STAFF REPORT: 11/12/2025 MEETING

ADDRESS: 8002 KERCHEVAL

APPLICATION NO: HDC2025-00640

SCOPE: REPLACE SIDING WITH FIBER CEMENT SIDING

Note that the Hardi Artisan cement fiber siding provides a profile that better matches that of tradition lapped wood siding. This is an image from the 2018 staff report

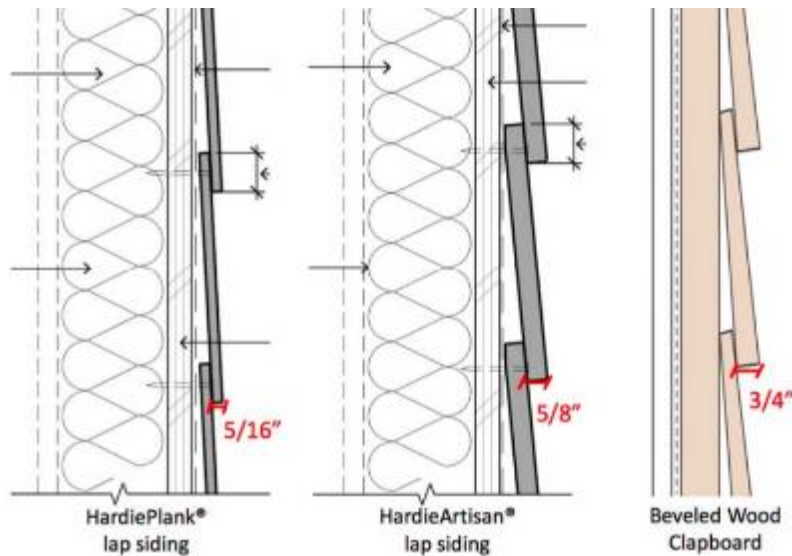
Staff notes that the 2018 application **did not** specify the brand or dimensions of the proposed cement fiber siding. The staff report therefore noted that the commonly available cement fiber siding product, manufactured by James Hardy, came in two lines, “HardiPlank” and “Artisan”. Staff provided the following graphic (see below), which compared both lines and noted that the James Hardy’s “Artisan” line provided a better match to traditional lapped wood siding in profile/thickness (at 5/8”), as opposed to James Hardy’s “HardiPlank” line (at 5/16”), which was too thin to adequately match the profile of traditional beveled/lapped wood siding.

8002 Kercheval, west/side elevation. Current condition. Photo by applicant, notes added by staff.

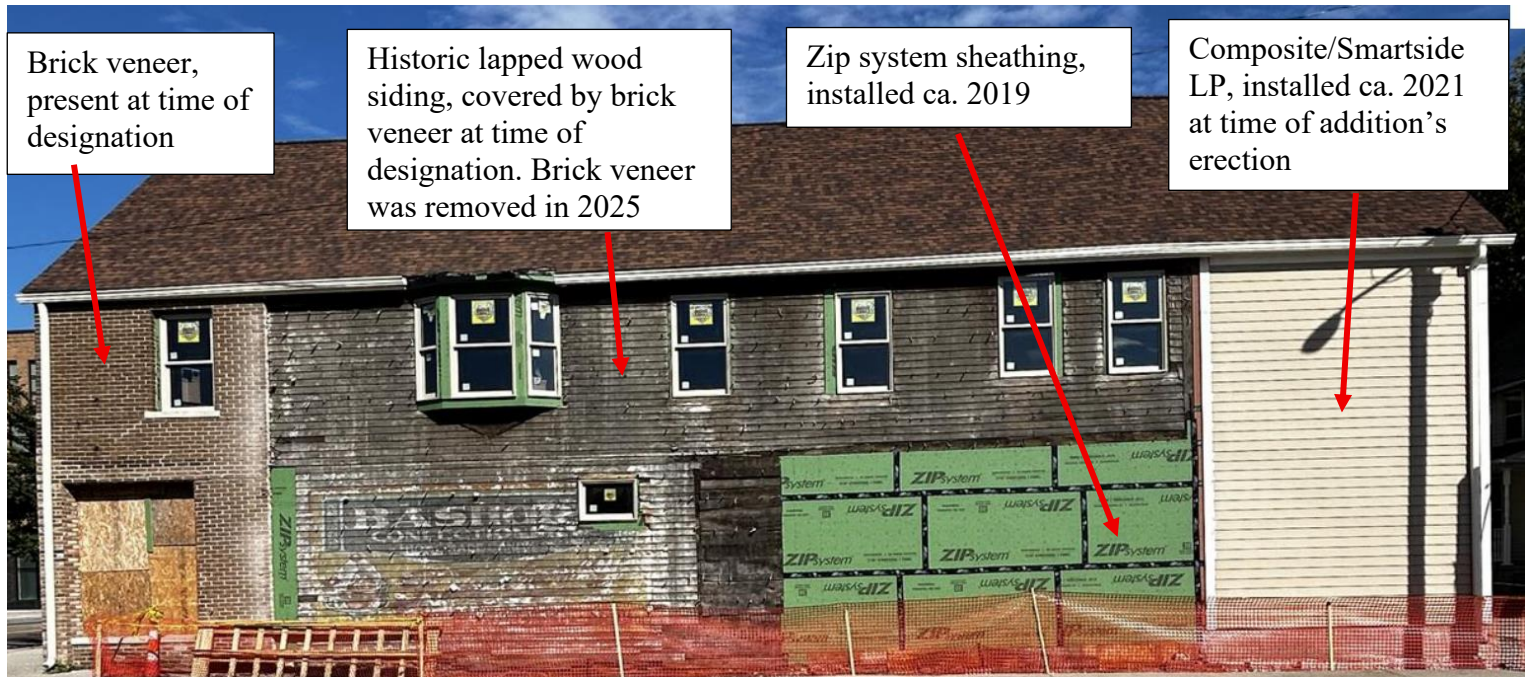
- The historic wood siding at the side elevations has only recently been revealed after the removal of the brick veneer and asphalt/Insulbrick siding. Staff was able to view the condition of the siding from the public right-of-way and did not find that it was deteriorated to an extent that merits its wholesale removal as proposed. Also, the application does not provide documentation that the historic wood siding is deteriorated beyond repair.

- Staff notes that the presence of an historic sign for "Bashor Confectioner Homemade Candy" at the first story of the newly revealed wood siding at the building's west façade (see above photos). Historic District Commission's "Signs and Awning" guidelines [Microsoft Word - Signs & Awning Guidelines FINAL](#) recommend that property owners "preserve historic signage when possible." Similarly, the National Park Service recommends that historic signs be retained whenever possible, particularly when they are "significant as reflecting the history of the building..." [Preservation Brief 25: The Preservation of Historic Signs](#). Research of historic newspapers (see below) revealed that the building housed businesses related to confectionary/candy making as early as 1927 through the 1960s.
